**Intel<sup>®</sup> 82371AB PIIX4,  
Intel<sup>®</sup> 82371EB PIIX4E,  
Intel<sup>®</sup> 82371MB PIIX4M**

**Specification Update**

*January 2002*

Document Number: [297738-017](#)

##### QUEUE HEAD LINK POINTER (DWORD 0: 00-03h)

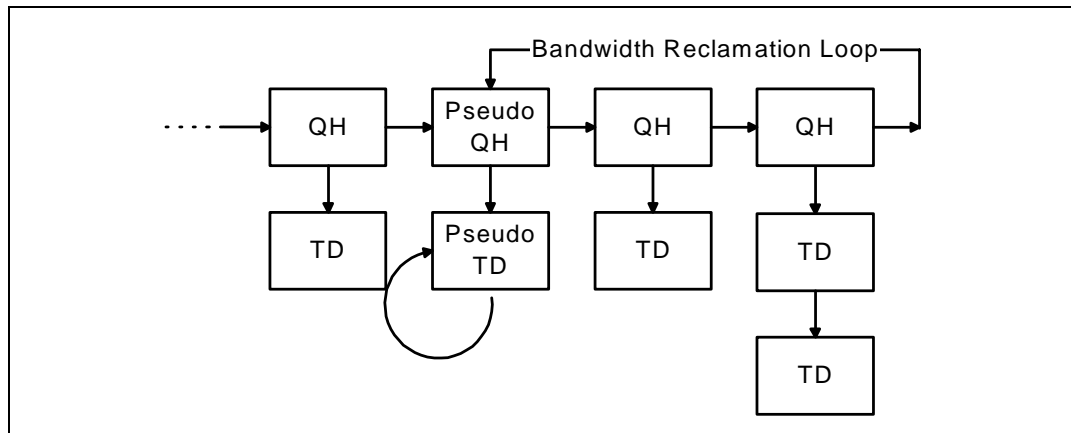
The Active status bit (bit 23) must be left unset at 0 indicating that the PIIX4/PIIX4E/PIIX4M should not execute this TD.

The Queue Head Link Pointer (QHLP=bits [31:4]) must be set to point to the pseudo TD.

The QH/TD Select (Q=bit 1) must be set to 1 indicating it is a QH.
